**MEMORANDUM**

**TO:** Department of Conservation  
**ATTN:** Chris Visser and Stewart Genery  
**FROM:** Mitchell Partnerships Limited on behalf of Riverstone Holdings Limited  
**DATE:** 21 October 2011  
**RE: APPLICANT'S RESPONSE TO THE DRAFT DETERMINATION REPORT  
– COMMENTS**

## FLE - TYPICAL DIMENSIONS FOR FOOTPRINT CALCULATION

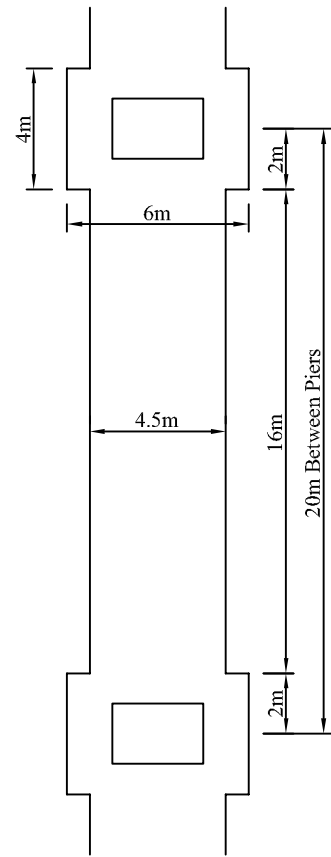
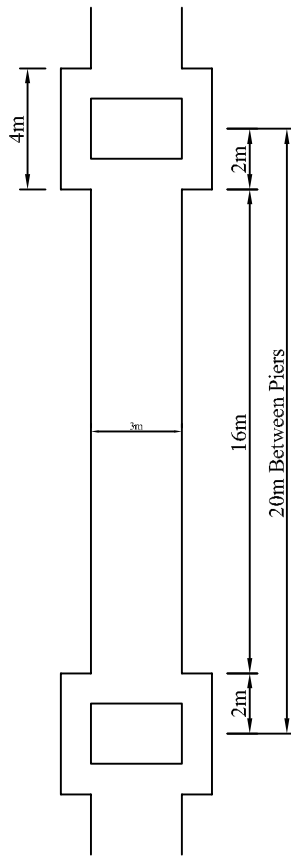
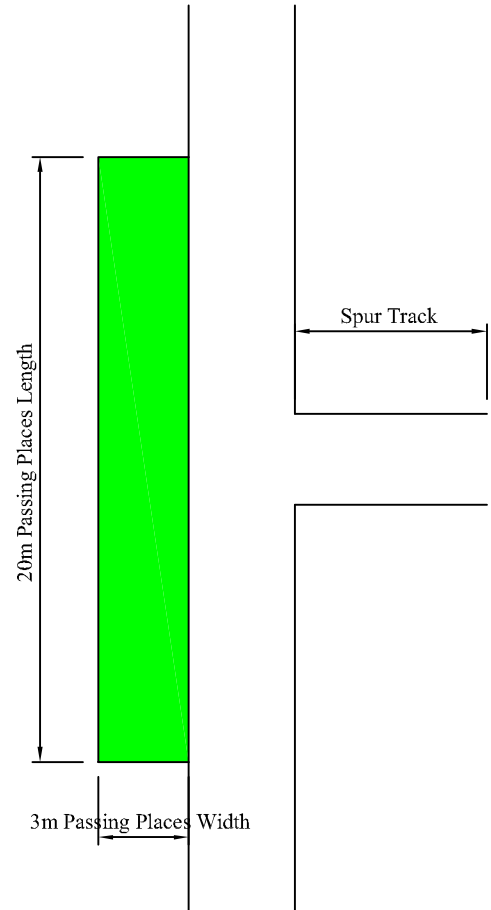
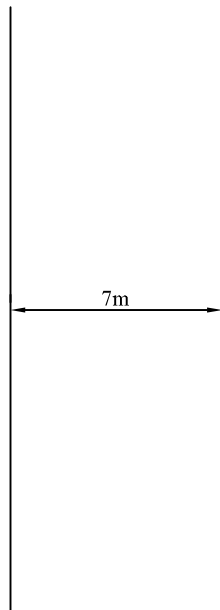
You have asked that we provide detail as to how the intended clearance areas have been calculated. The clearance figures presented by RHL were estimated by Opus International Consultants (Opus) using the information that has been developed for the construction methodology (with inputs from other advisors including ecological) to date. The spreadsheet and accompanying dimension sketch attached as **Appendix B** illustrates how these figures have been derived.

Wide Width Percentage =  $(2+2)/20 = 20\%$

Narrow Width Percentage =  $16/20 = 80\%$
